# UNITED STATES PATENT AND TRADEMARK OFFICE

APPLICATION NO.	FILING DATE	FIRST NAMED INVENTOR	ATTORNEY DOCKET NO.	CONFIRMATION NO.
10/700,801	11/03/2003	Alfred Geissler	0250-130	6267
616	7590	02/04/2005	EXAMINER	
THE MAXHAM FIRM 750 "B" STREET, SUITE 3100 SAN DIEGO, CA 92101			CADUGAN, ERICA E	
			ART UNIT	PAPER NUMBER
			3722

**Office Action Summary**

## **DETAILED ACTION**

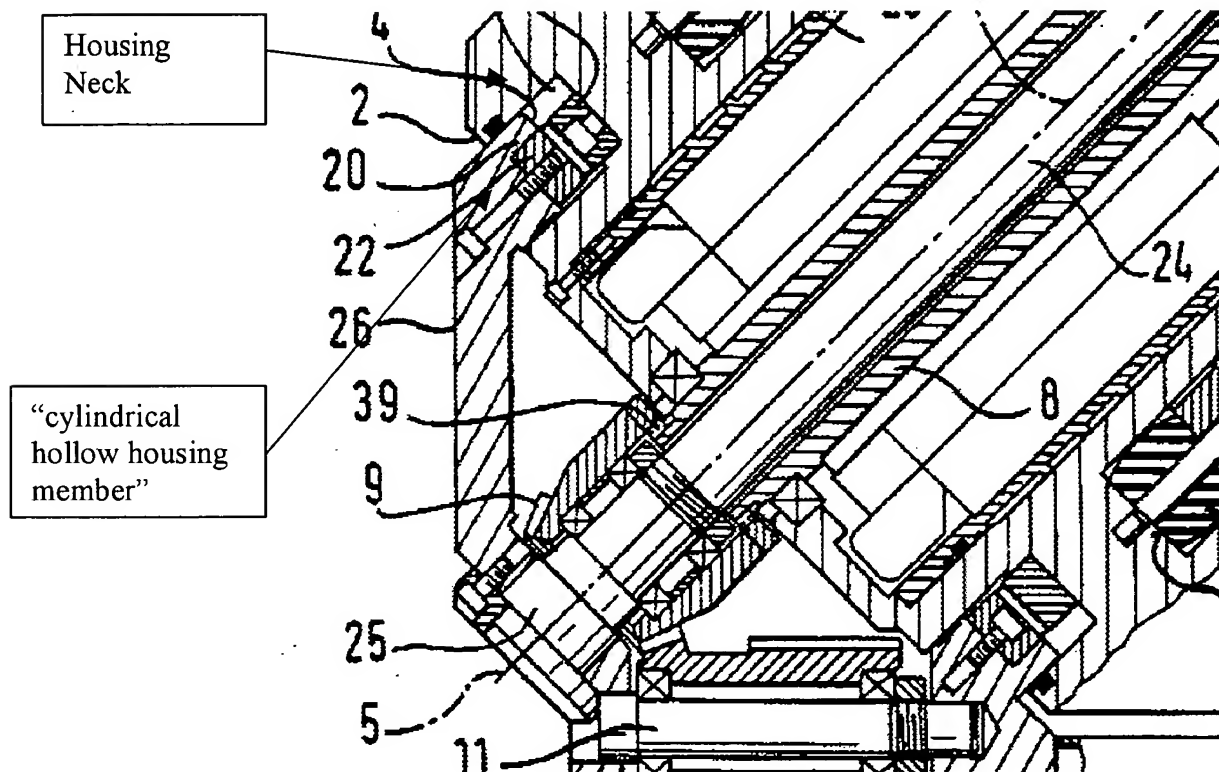
“Spindle motor” 7 is mounted in the “head support” 1 (Figure 3), and is “aligned coaxially” with respect to swivel axis 5 (see Figure 3 and col. 3, lines 46-48). Motor 7 “has” a shaft 24. At least ultimately “on” the end of shaft 24 that protrudes from “head support” 1, a bevel gear 9 is “arranged” (see Figure 3, see also col. 4, lines 58-60 and col. 5, lines 7-10). Shaft 24 is used to rotate the swivel head 3 about the axis 5 (see Figure 3 and col. 4-5).

Additionally, the swivel head 3 has a "cylindrical hollow housing member" coaxial with axis 5 that is rotatable within a neck in the "head support" 1. See the partial reproduction of Figure 3 below.
